AAMA TESTIMONY SEPTEMBER 28, 1998 CARB HEARING

**CARB Hearing on LEV Program Revisions
September 28, 1995**

**General Motors Statement at the California Air Resources Board Hearing
to Consider Amendments to the Low Emission Vehicle Program
September 28, 1995**

WSPA appreciates the opportunity to comment on the California Air Resources Board's (CARB) "Proposed Amendments to Low-Emission Vehicle Regulations" dated August 11, 1995, and on the supporting Air Modeling Report dated June 22, 1995.

Figure 2

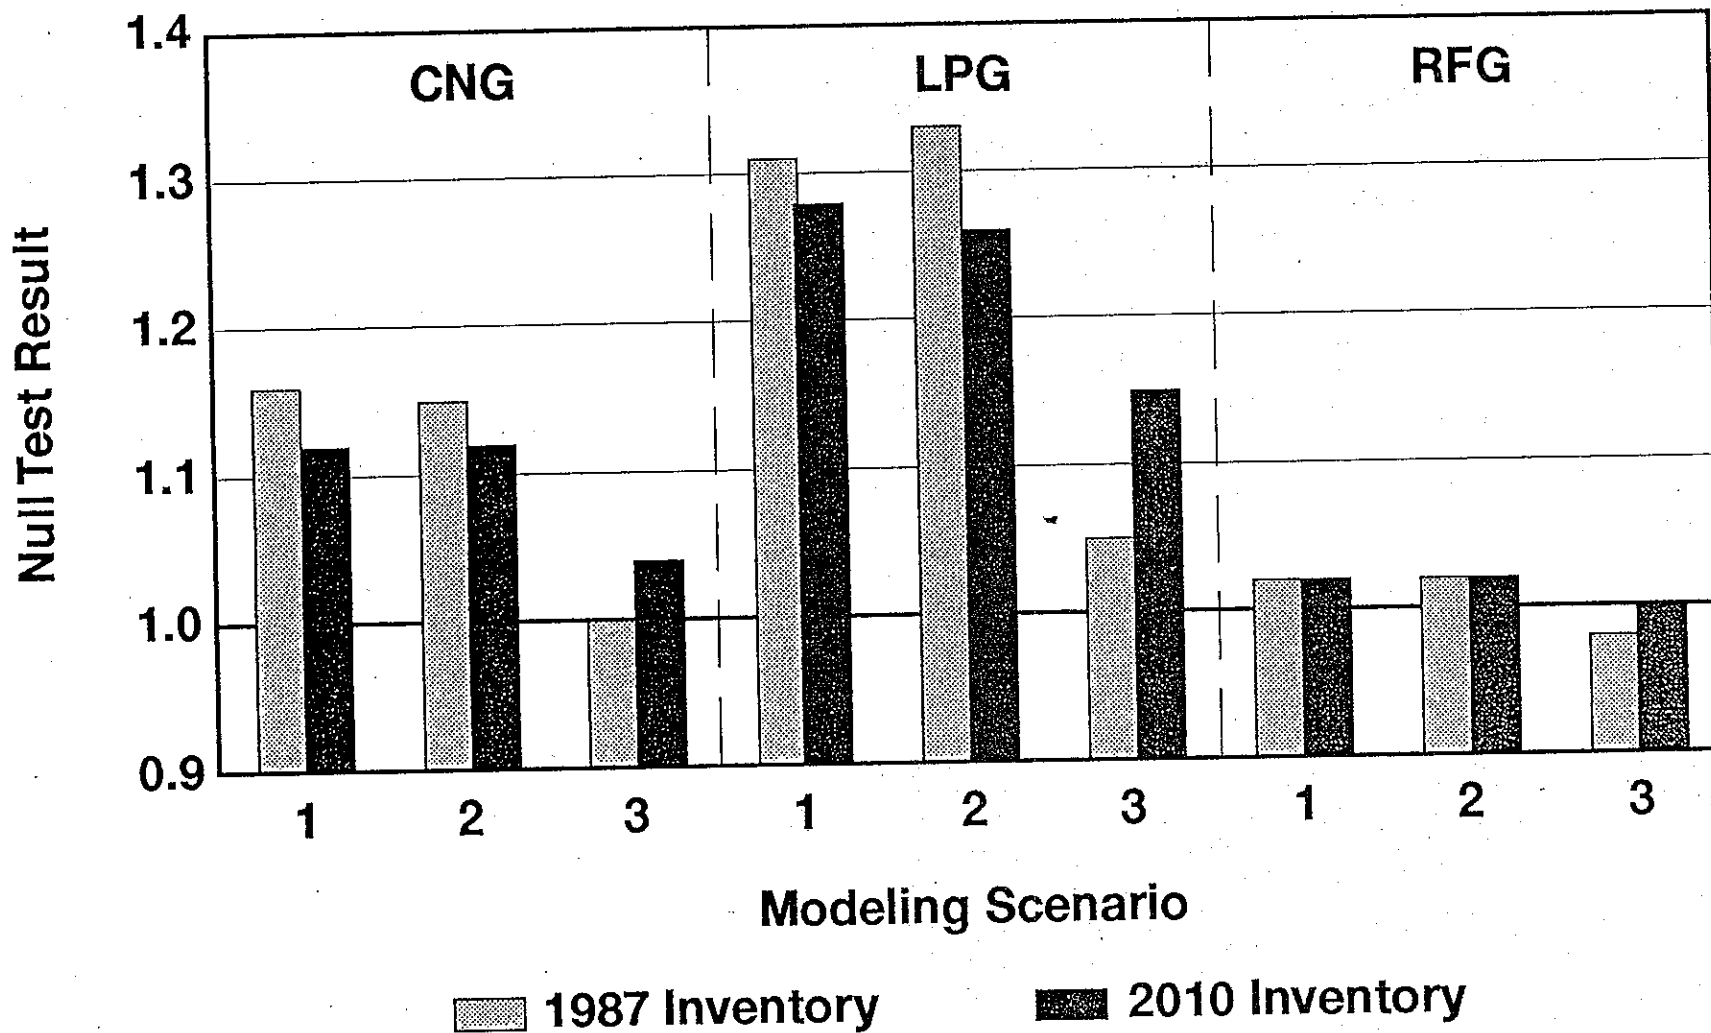
Figure 2 depicts the peak ozone null test results from modeling of CNG-, LPG-, and RFG-vehicle cases. These results are taken directly from the CARB Air Modeling Report of June 22, 1995. This figure clearly illustrates that application of the proposed RAFs for both CNG- and LPG-fueled LEVs would be expected to increase peak ozone in the South Coast Air Basin when compared with either RFG- or conventional gasoline-LEVs. To achieve equivalent ozone impacts, these modeling results indicate that both CNG and LPG RAFs need to be adjusted upward.
